<b>COMPRESSOR PMAZ23 FOR THE MAZDA 3</b>					TSB #:	<b>61</b>
					Date:	<b>24/5/2012</b>
Initial Once Read:

Internal view of a National Panasonic vane compressor provided by Air International Thermal (Australia)

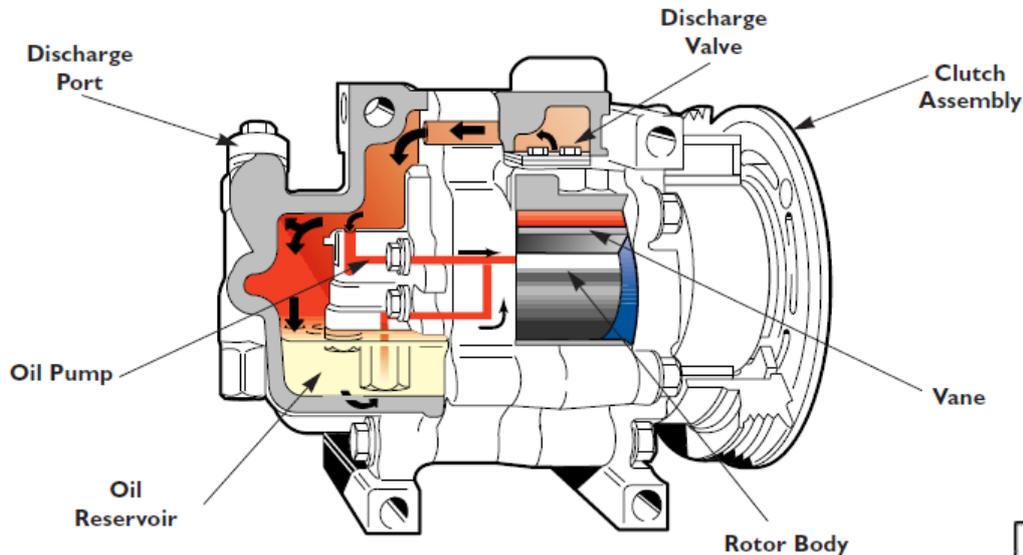
1. *Internal vane "rattling" noise heard on initial compressor engagement at idle.* The vane noise should normally disappear in a matter of minutes. If the noise does not disappear after 10 minutes, hold the engine speed at approximately 3,000 rpm for 5 minutes. The vanes located in the rotor body require both refrigerant pressure and lubricating oil to act as a cushion behind the vane. The cushioning effect ensures full sealing of the vane against the cylinder wall.

2. *Clutch front plate turning anticlockwise when the compressor cycles off.* This is normally an indication of damaged reed valves which then allows refrigerant pressure feed in the opposite direction and turns the compressor backwards. It is essential that you follow the charging procedure as described previous as broken reeds may be the result of excessive liquid refrigerant being fed into the low side. If you experience this issue—replace the compressor.
